Eight Discipline Report (8D Report)

To: Dell	8D report No.: N/A
From: : Chicony Power Technology	RMA claim No.: N/A
CC: CPT DQA	Chicony Power P/N: N/A
	Customer P/N: N/A
Submit date: 2019/11/19	Product description: Dell E4 130W
Receive date: 2019/11/08	
	-

Subject: EMI – Conduction Issue of E4 130W

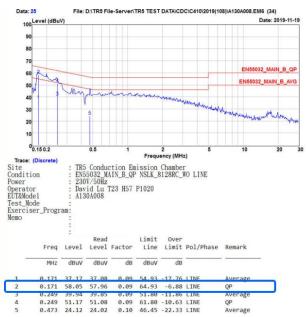
- Reconfirm this adapter, it's fail of CE test as same as factory feedback.
- ➤ After removed the glue as below picture, the EMI could be improved to -6.36dB. The glue had contact Pi choke (L101) & PFC choke (L2) and PFC bead (B101). It cause EMI noise can bypass L101 to make EMI margin issue.

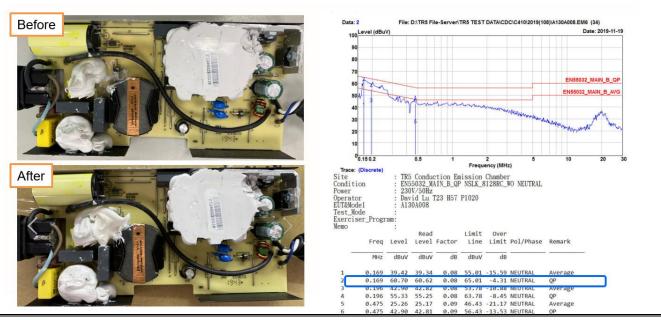
Change glue location as below picture to avoid glue contact PFC choke and PFC bead.

Proven effectiveness through repeated verification and replicable experiments

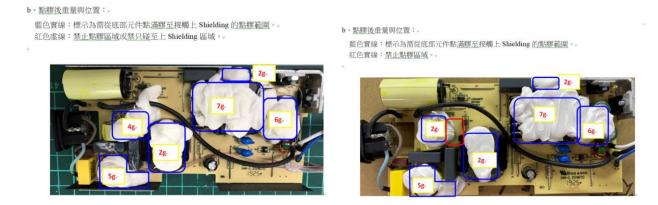
Correct WI to prevent the occurrence of problematic products again.
